**Oakland City Planning Commission
Design Review Committee**

STAFF REPORT

Case File Number: ZP160026

Project Location : Assessor's Parcel Numbers:	1431 Jefferson Street (between 14th and 15th Streets) 003 007101801 & 003 007101900
Proposal:	To construct an 18-story, 276 room hotel with ground-floor retail and a four-story partially covered parking garage above street level.
Applicant/ Phone Number:	Michael Stanton Architecture / (415) 865-9600
Property Owner:	Karan Suri
Case File Number:	ZP160026
Planning Permits Required:	Regular Design Review for new construction.
General & Estuary Plan:	Central Business District
Zoning Districts:	CBD-P, CBD-X
Environmental Determination:	Environmental analysis under review
Property Historic Status:	Non-Historic Property
City Council District:	3
Action to be Taken:	Conduct design review, make recommendations to applicant.
For Further Information:	Contact Case Planner, Mike Rivera at (510) 238-6417, or by email at mriviera@oaklandnet.com

DRAWING TITLE
NORTH ELEVATION - 15TH ST

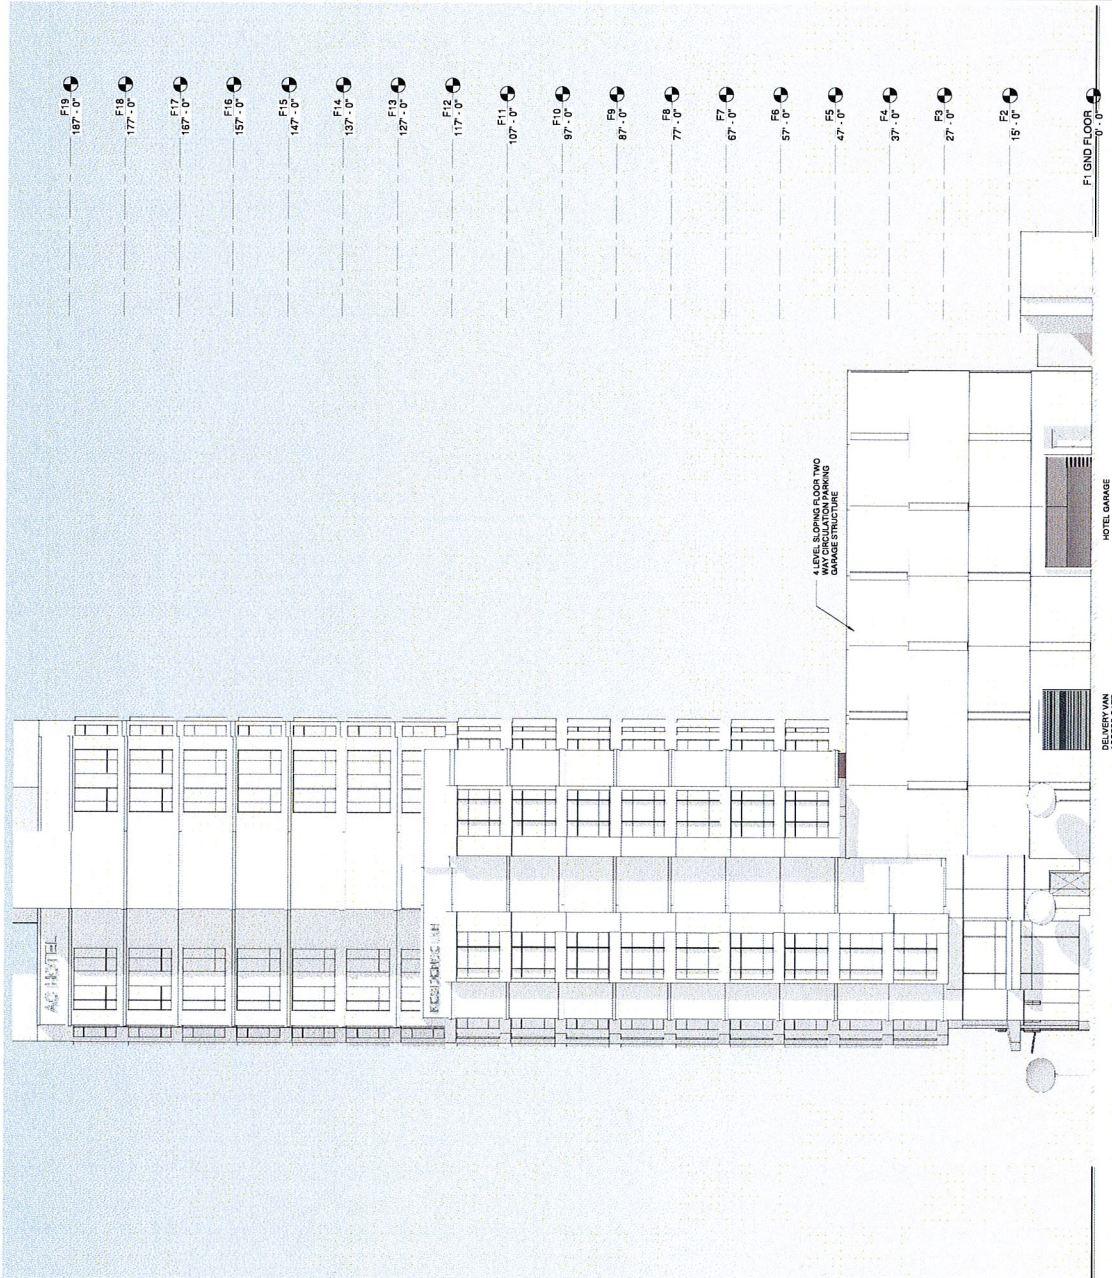
The proposal meets this standard because the design includes grey stone siding on the exterior of the 1 st and 2 nd floors of the building. Staff, however, recommends that the lower dark color bulkhead in front of the building should extend along the exterior wall of the hotel business center, office and reception rooms. In addition, staff recommends further development should be made to improve the north side of the exterior building facade on 15th Street.

3. Consider revising the garage to provide more texture.

Response: The bulkhead has been extended along the entire perimeter of the building. Additionally the garage facade along 15th St has been broken into panels that shift in plane and provide an interesting read to the facade. Additionally thin vertical windows have been provided to set rhythm to the facade.

Response: The facade of the parking garage has been revised to read as a set of broken planes refer to A501, A027, A028, A029. A031.

DRAWING TITLE
WEST ELEVATION

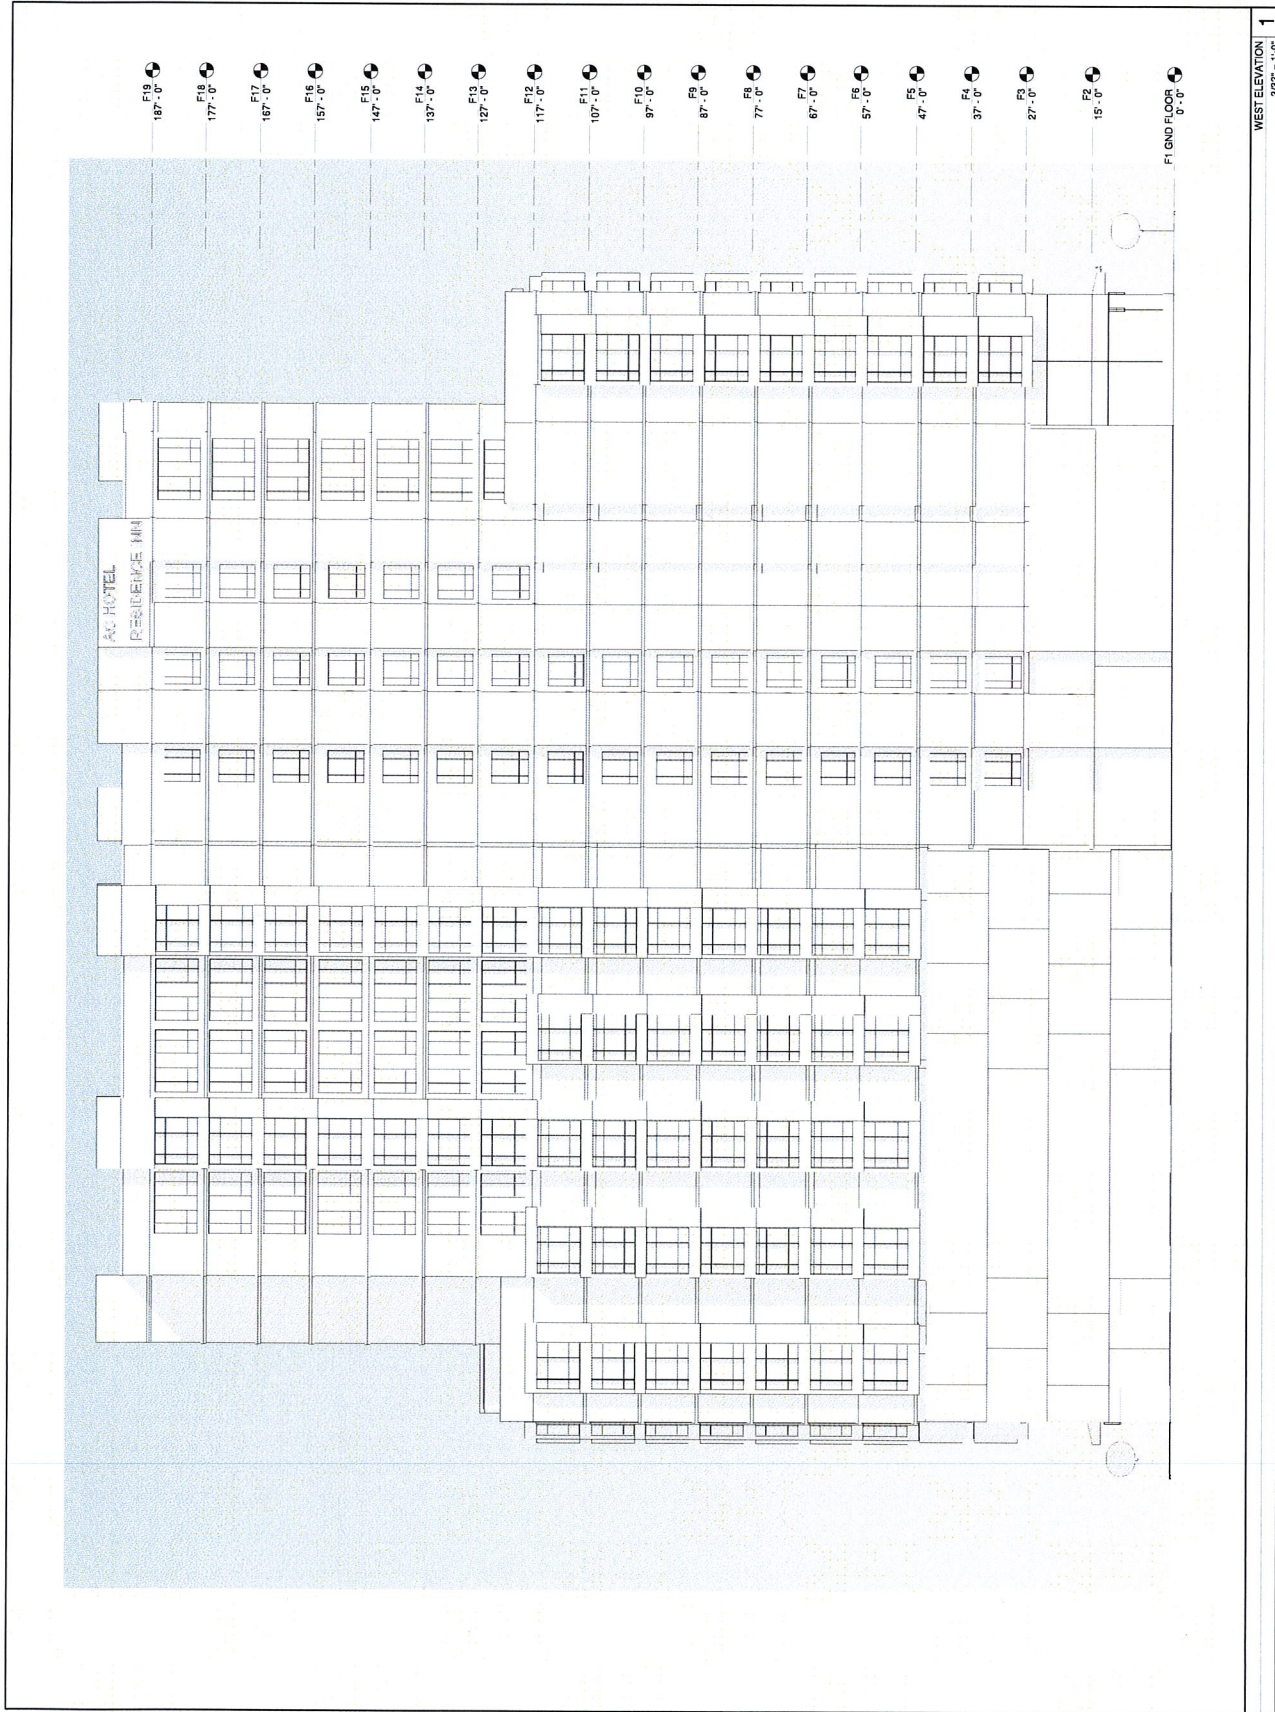
The proposal meets this standard as the project provides upper story windows on all street-fronting facades. Staff recommends the applicant further explore the installation of other type of window alternatives along the north side of the building to create visual interest. This includes the installation of windows, if feasible, along the west side of the 18-story high-rise building.

Continue to develop and articulate the "blank" building wall located to the west side of the high-rise and to the north side of the low-rise building.

4. Reduce west facade blank wall.

Response: The South end of the west facade has been revised, portions of the facade have been recessed and windows have been placed to reduce the blank wall effect. Refer to Sheet A015 & A504.

Response: The articulation has been added to the west facade to reduce the blank wall appearance of the facade.

Response: The west facade has been revised, a set of 3 strong recesses have been added at the south end and windows have been added to reduce the blank wall read. See A504.
